**STATEMENT OF WORK for CONSTRUCTION SERVICES**  
**Office/Maintenance Facility**  
**At**  
**Bon Secour National Wildlife Refuge**  
**(Approximately at 30.2526, -87.8133)**  
**South Atlantic-Gulf & Mississippi Basin Region**

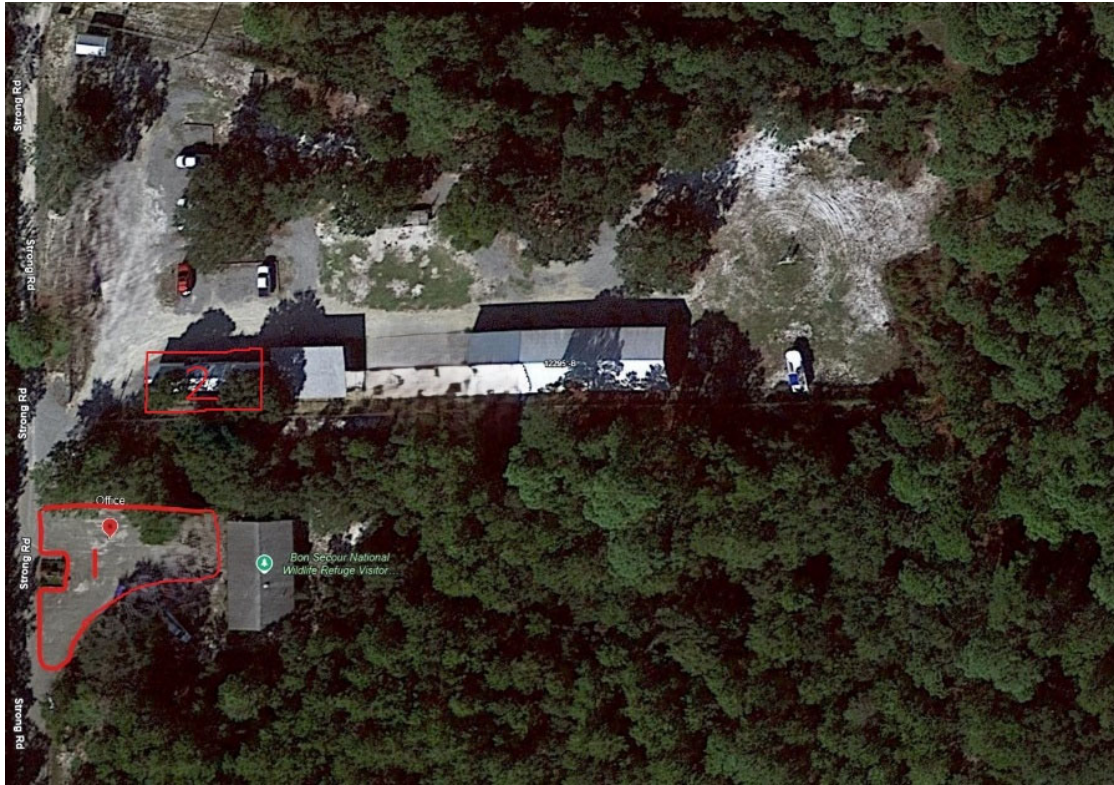
14. Can you please confirm if there will be designated lay down areas for contractor operations?

20. Please provide location staging area(s) will be allowed/designated?  
**USFWS Response** We can use the existing parking lot (1) and footprint of former mobile maintenance trailer (2) for staging areas and materials and keep Strong road open for public traffic. We need to maintain an 8 foot wide access to the existing headquarters in the parking lot. See aerial photo in response to question 14.

**USFWS Response-** We can use the existing parking lot (1) and footprint of former mobile maintenance trailer (2) for staging areas and materials and keep Strong road open for public traffic. We need to maintain an 8 foot wide access to the existing headquarters in the parking lot. Please also note that when existing maintenance yard is removed, a temporary fence must be installed as per the requirements in the construction drawings (GENERAL, SHEET 2 OF 91, G-002, PART 15) and in specifications 01 50 00 Temporary Facilities and Controls, 10 71 33, Protection of Work and Property.
